Lot 73 CHESTER STREET 431-C-17

House Dwelling for Hildrith Urquhart at Sts. 70-71
6/19/46

Subject: Building permit to cover construction
one-family dwelling house with attached
garage at Lot 73 Chester Street

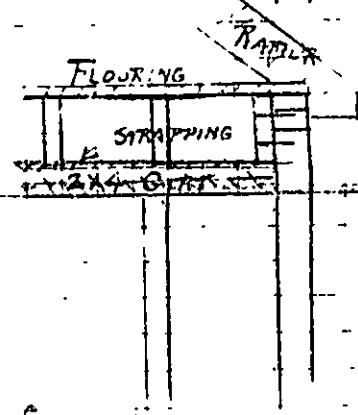
Max. span = 8'
 6x8 dressed hemlock 8' span = 4726 #
 11x8x37 = 3256 # 6x10 dressed hemlock
 11x6x27 = 2376 # 8' span = 7584 #
 2(7.5x6x18) = 2160 #
 7292 #
 6x8 dressed hemlock 6' span = 6302 #
 11x6x37 = 2422 #
 11x6x27 = 1782 #
 2(7.5x6x18) = 1620 #
 5824 # - O.K.

Since the 8' span occurs only between fireplace and rear foundation wall and 6x10 hemlock would quite securely it would seem as if Kerttula's direct-
 ly over this girder in first story, which has a door opening in the center might be trussed and the 6x8 girder used, thus avoiding the use of another column in cellar. The maximum span req'd for girders is 6', which figured O.K.
